# Access Compliance Report

## Public Rights-of-Way (Curb Ramps)

Intersection ID: 3079	Main Street: BLACK_MAPLE_AV	Cross Street: PLACER_MAPLE_LN	Location: NW
ADA ID: 0D5C63AD001E	Ramp Type: Perp	Initial Pass/Fail: Fail	Overall Compliance: No
Severity Score: 22.5			
Codes/Mitigation Info/Possible Solution		Field Measurements/Component Compliance

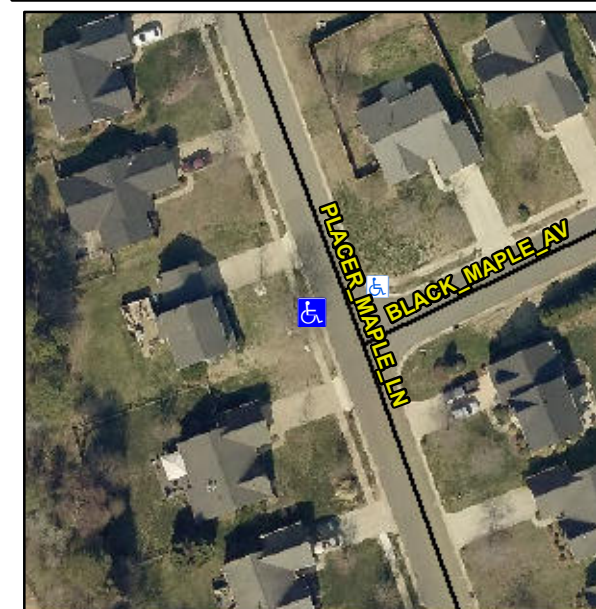
**Remove & Replace Entire Ramp.**

**Not Found, R304.5.1, R304.2.2, R304.5.3**

Compliance	Description	Data	Compliance	Description	Data
N/A	Ramp Length (in)	48.5	No	Ramp Slope (%)	8.8
No	Ramp Width (in)	45.0	No	Ramp XSlope (%)	3.7
N/A	Flare Type LT	N/A	N/A	Flare Type RT	N/A
N/A	Flare Slope LT (%)	N/A	N/A	Flare Slope RT (%)	N/A
N/A	Flare Traversable LT?	N/A	N/A	Flare Traversable RT?	N/A
N/A	Landing Length (in)	N/A	N/A	DWS Provided?	N/A
N/A	Landing Width (in)	N/A	N/A	DWS Contrast?	N/A
N/A	Landing Slope (%)	N/A	N/A	DWS Length (in)	N/A
N/A	Landing X Slope (%)	N/A	N/A	DWS Full Width?	N/A
N/A	Landing Curb? (Y/N)	N/A	N/A	DWS Offset (in)	N/A
N/A	Shared Landing?	N/A			
N/A	Gutter Ponding?	N/A	N/A	Gutter Slope (%)	N/A
N/A	Gutter Lip Ht (in)	N/A	N/A	Gutter X Slope (%)	N/A
N/A	Painted X Walk1?	No	N/A	Painted X Walk2?	N/A
	X Walk 1 Direction	To E		X Walk 2 Direction	N/A
N/A	X Walk 1 Width (in)	N/A	N/A	X Walk 2 Width (in)	N/A
	X Walk 1 Slope (%)	2.0		X Walk 2 Slope (%)	N/A
	X Walk 1 X Slope (%)	2.9		X Walk 2 X Slope (%)	N/A
